Access Compliance Report

Public Rights-of-Way

(Curb Ramps)

Intersection ID: 7422	Main Street: BOXMEER_DR	Cross Street: STATESVILLE_RD	Location: NW
ADA ID: B56E9ACA85B3	Ramp Type: Perp	Initial Pass/Fail: Fail	Overall Compliance: No
Codes/Mitigation Info/Possible Solution		Field Measurements/Component Compliance	
Severity Score: 36.25

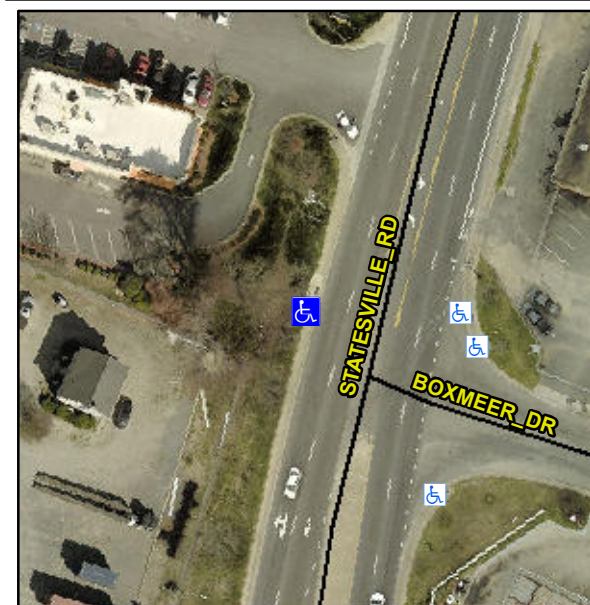
Not Found, R304.5.1, R304.2.2, R302.7

Compliance	Description	Data	Compliance	Description	Data
N/A	Ramp Length (in)	60.0	No	Ramp Slope (%)	10.7
No	Ramp Width (in)	36.0	Yes	Ramp XSlope (%)	0.8
N/A	Flare Type LT	N/A	N/A	Flare Type RT	N/A
N/A	Flare Slope LT (%)	N/A	N/A	Flare Slope RT (%)	N/A
N/A	Flare Traversable LT?	N/A	N/A	Flare Traversable RT?	N/A
N/A	Landing Length (in)	N/A	N/A	DWS Provided?	N/A
N/A	Landing Width (in)	N/A	N/A	DWS Contrast?	N/A
N/A	Landing Slope (%)	N/A	N/A	DWS Length (in)	N/A
N/A	Landing X Slope (%)	N/A	N/A	DWS Full Width?	N/A
N/A	Landing Curb? (Y/N)	N/A	N/A	DWS Offset (in)	N/A
N/A	Shared Landing?	N/A			
N/A	Gutter Ponding?	N/A	N/A	Gutter Slope (%)	N/A
N/A	Gutter Lip Ht (in)	N/A	N/A	Gutter X Slope (%)	N/A
N/A	Painted X Walk1?	No	N/A	Painted X Walk2?	N/A
	X Walk 1 Direction	To SE		X Walk 2 Direction	N/A
N/A	X Walk 1 Width (in)	N/A	N/A	X Walk 2 Width (in)	N/A
	X Walk 1 Slope (%)	4.5		X Walk 2 Slope (%)	N/A
	X Walk 1 X Slope (%)	1.3		X Walk 2 X Slope (%)	N/A

N/A	Ramp inside XWalk1?	N/A	N/A	Ramp inside XWalk2?	N/A
	Road Slope (%)	N/A	N/A	Clear Space?	N/A
	Road X Slope (%)	N/A	N/A	Clear Space to XWalk (in)	N/A
N/A	Any Obstructions?	N/A	N/A	Storm Grate/Utility Hazard?	N/A
	Obstruction Type			Storm Grate/Utility Type	
		N/A			N/A
		No		Surface Condition? (G/P)	Poor

Possible Solutions:

Remove & Replace Entire Ramp.
